**REVISED RESPONSE TO COMMENT ON THE SOUTH FIELD INJECTION
TEST REPORT**

**DOE-1089-96
DOE-FN EPAS
7
RESPONSES**

REVISED RESPONSE TO COMMENT ON THE SOUTH FIELD INJECTION TEST REPORT

FIGURE 6-13. MOUNDING WHICH RESULTED FROM THE INJECTION TEST AT AN ELAPSED TIME OF 2000 MINUTES

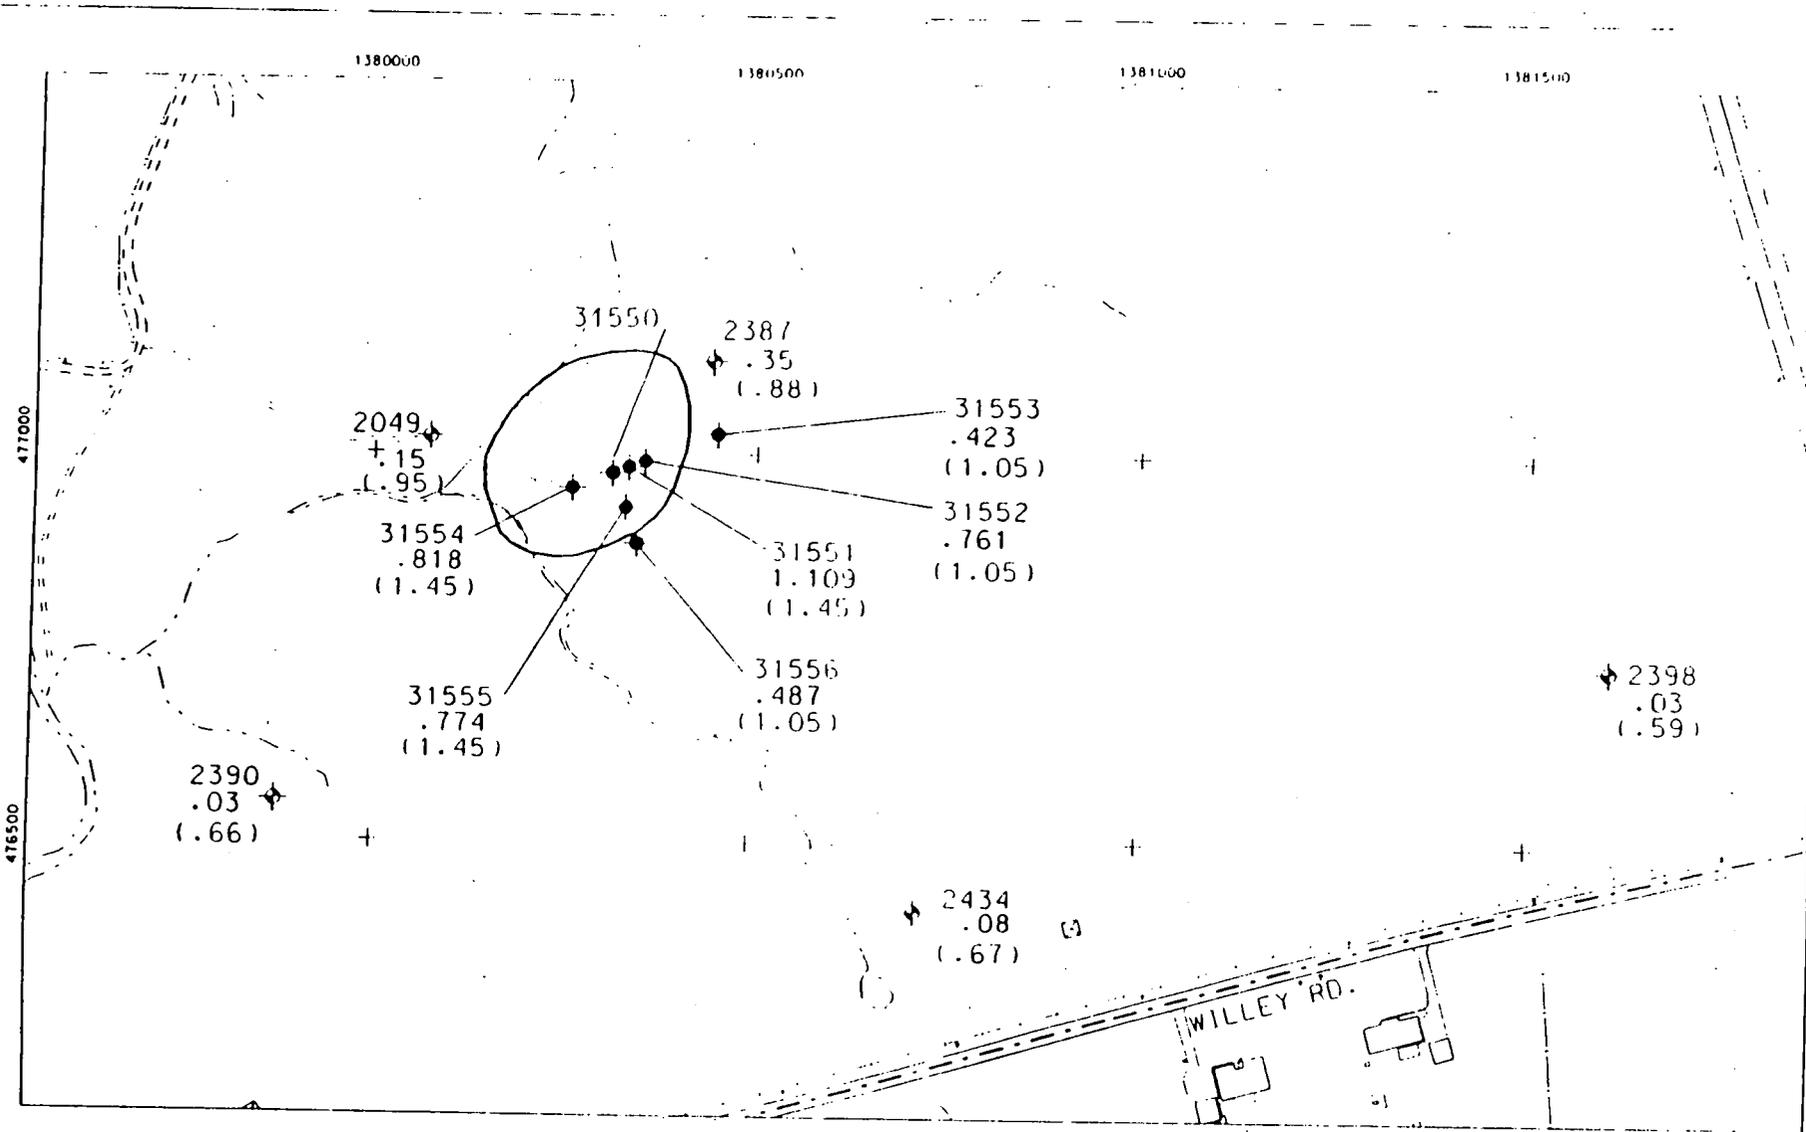
Comment: The report states that actual field conditions and modeled predictions of the water table rise are in close agreement. The water level rise of 1.0 foot in well 31550 does not seem to match any data presented for well 31550 in the report. The report should clarify where a 1.00 foot water level rise in well 31550 was measured. Additionally, before stating conclusions based on the model's ability to predict aquifer response to injection, the test should present a more rigorous model validation. This validation should use all data from all the wells affected in the test and calibration targets.

Response: The intent of the statement in question was to comment qualitatively on the ability of the SWIFT GMA Model to predict water elevation rises due to injection. The model predicted about 1.5 feet of rise, and the test produced a rise of about one foot in the area of the injection well. Errors on Figure 6.13 kept the figure from properly supporting the statement. It was thought that by revising the figure the meaning of the statement would become clear. By making the statement though, the question has been raised as to the validation and calibration of the SWIFT GMA model under injection conditions. A rigorous presentation of the calibration and validation of the groundwater model under steady state pumping conditions is presented in The SWIFT Great Miami Aquifer Model, Summary of Improvement Report, Volumes I and II, 1994. Each step of the remediation involves constant pumping and/or injection for a period of several years during which time it is expected that steady state flow conditions will be achieved. Because the remediation was designed using steady state modeling it seems appropriate to assess injection under steady state conditions also.

Action: Figure 6-13 will be corrected. The notations for wells 31551 and 31556 will be changed to read 1.109 feet and 0.487 feet respectively. With these

corrections, the figure will properly illustrate and support the statement regarding modeling predictions.
